<b>Title - Sujet</b> 50 Bed Living Unit, Westmorland Ins	
<b>Solicitation No. - N° de l'invitation</b> EC016-130878/A	<b>Amendment No. - N° modif.</b> 018
<b>Client Reference No. - N° de référence du client</b> R.043929.001	<b>Date</b> 2012-09-18
<b>GETS Reference No. - N° de référence de SEAG</b> PW-\$PWB-020-3101	
<b>File No. - N° de dossier</b> PWB-2-35024 (020)	<b>CCC No./N° CCC - FMS No./N° VME</b>
<b>Solicitation Closes - L'invitation prend fin</b> <b>at - à 02:00 PM</b> <b>on - le 2012-09-25</b>	<b>Time Zone</b> <b>Fuseau horaire</b> Atlantic Daylight Saving Time ADT
<b>F.O.B. - F.A.B.</b> <b>Plant-Usine:</b> <input type="checkbox"/> <b>Destination:</b> <input type="checkbox"/> <b>Other-Autre:</b> <input type="checkbox"/>	
<b>Address Enquiries to: - Adresser toutes questions à:</b> Donovan, Janine PWB	<b>Buyer Id - Id de l'acheteur</b> pwb020
<b>Telephone No. - N° de téléphone</b> (506) 636-5347 ( )	<b>FAX No. - N° de FAX</b> (506) 636-4376

This Tender Amendment Number 18 is raised to include the following **Addendum No. 18.**

## **Addendum No. 18**

DRAWING No. CSK-001

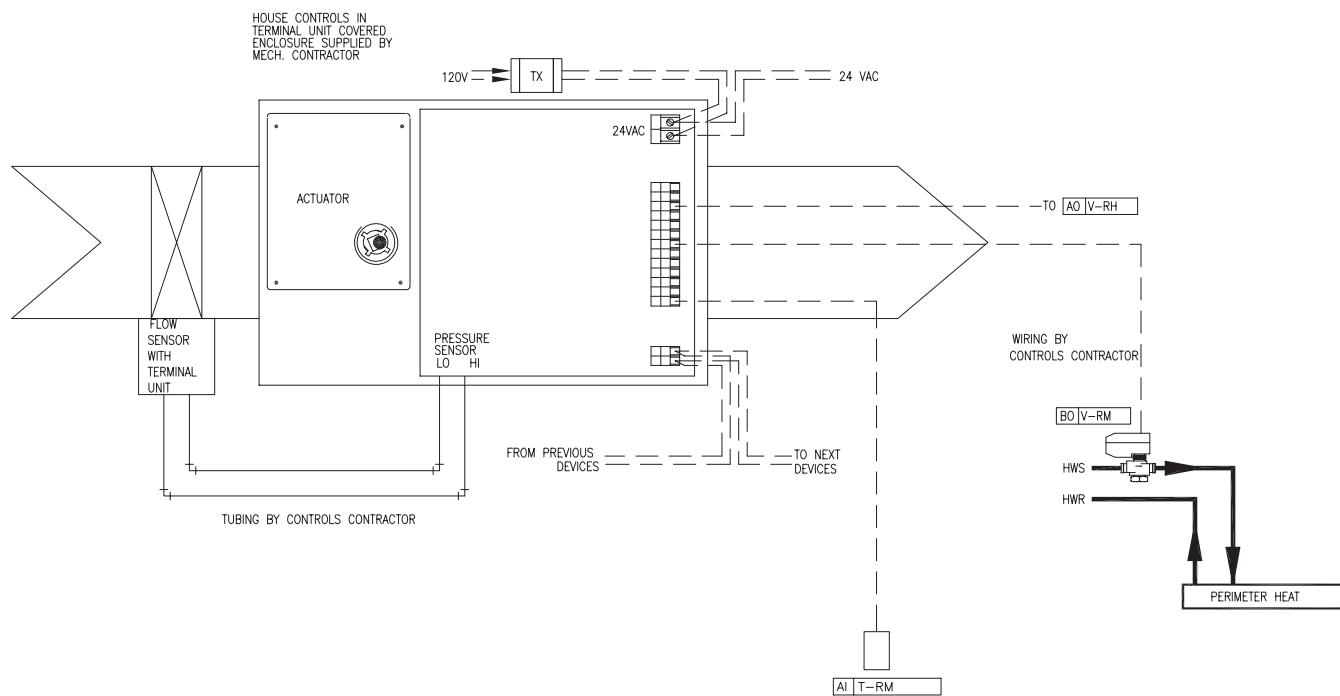
DRAWING VAV TERMINAL CONTROL
